L-PI-11-068
10 CFR 50.90

Prairie Island Nuclear Generating Plant Units 1 and 2
Dockets 50-282 and 50-306
Renewed License Nos. DPR-42 and DPR-60

Response to Requests for Additional Information (RAI) Associated with Adoption of the Alternative Source Term (AST) Methodology (TAC Nos. ME2609 and ME2610)

Response to SCVB Clarification Question

Figure 1 - As-Built Shield Building Leakage Limit

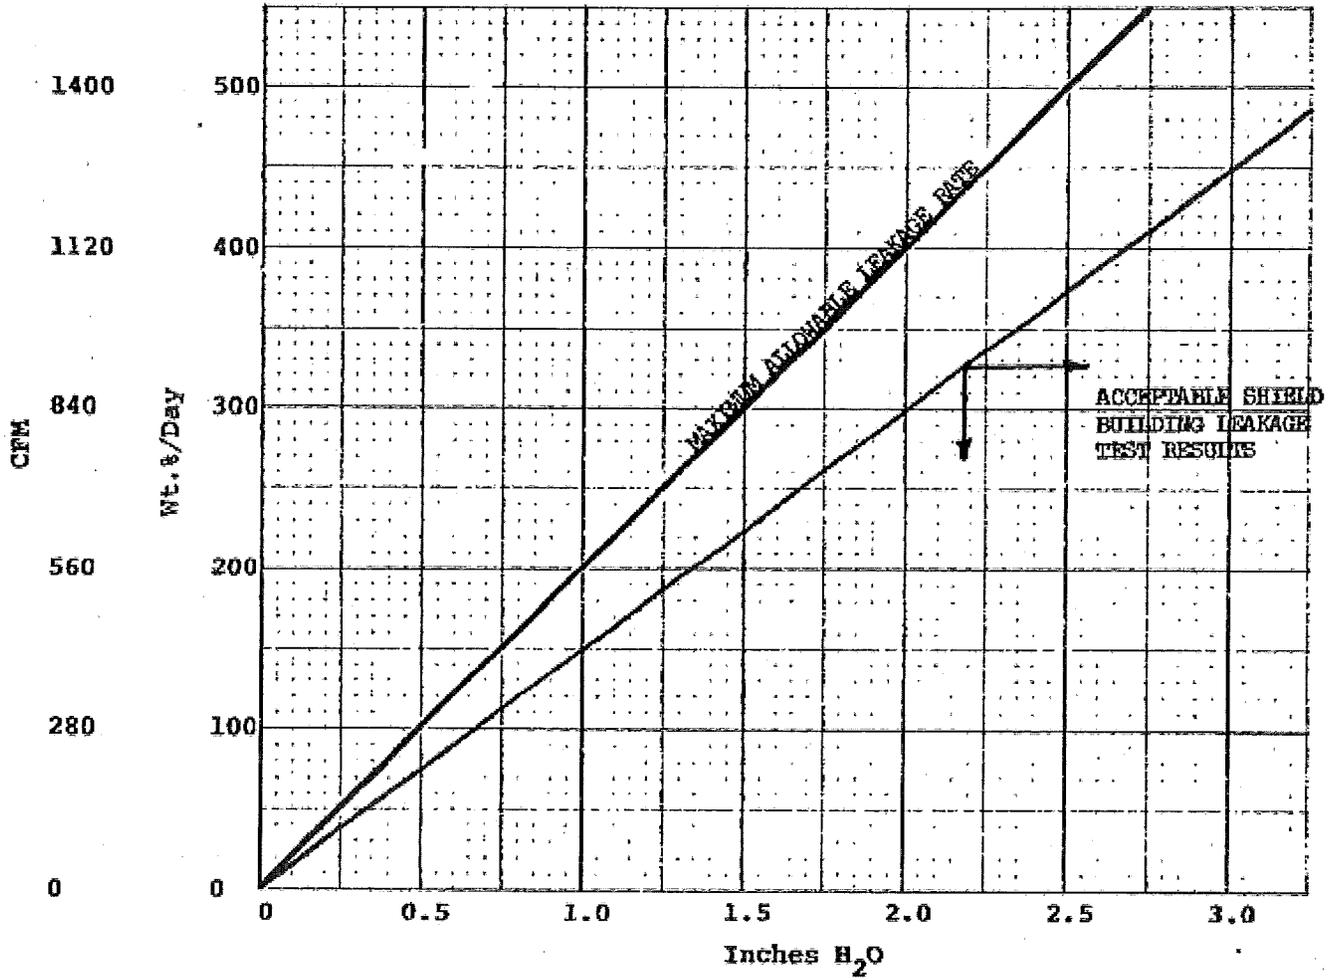
How often does the licensee verify the venting and/or leakage rate(s) represented in Table 2?

Leakage at an equilibrium pressure of 1.82" H₂O corresponds to 75% of the maximum allowable shield building in-leakage as cited in the Bases for SR 3.6.10.2. Figure 1 on Page 7 (Reference 2, Figure 5) provides two curves; one showing the maximum allowable leakage rate (former TS Figure 4.4-1) and the other showing the acceptable shield building leakage test results. As shown, the acceptable shield building leakage test results are 75% of the maximum allowable leakage rate. Furthermore, Figure 1 shows that at 1.82" H₂O the maximum allowable leakage rate is 1000 cfm. Figure 2 on Page 8 (Reference 2, Figure 4), shows the SBVS pull-down transient with the Technical Specification maximum leakage rate (i.e., the acceptable shield building leakage test results from Figure 1). As shown on Figure 2, the SBVS pull-down transient curve, the equilibrium differential pressure corresponding to an inleakage rate of 75% of Figure 5 is 1.82" H₂O.

In conclusion, the current methods used to test the SBVS are acceptable and additional exhaust flow or leakage testing is not required, as described in more detail above. Every 31 days, SBVS surveillance testing of differential pressure confirms that the shield building in-leakage (equal to exhaust flow) is less than or equal to 750 cfm, which is 75% of the maximum allowable shield building in-leakage. This confirms that the SBVS leakage and exhaust do not exceed the values used in the dose analysis.
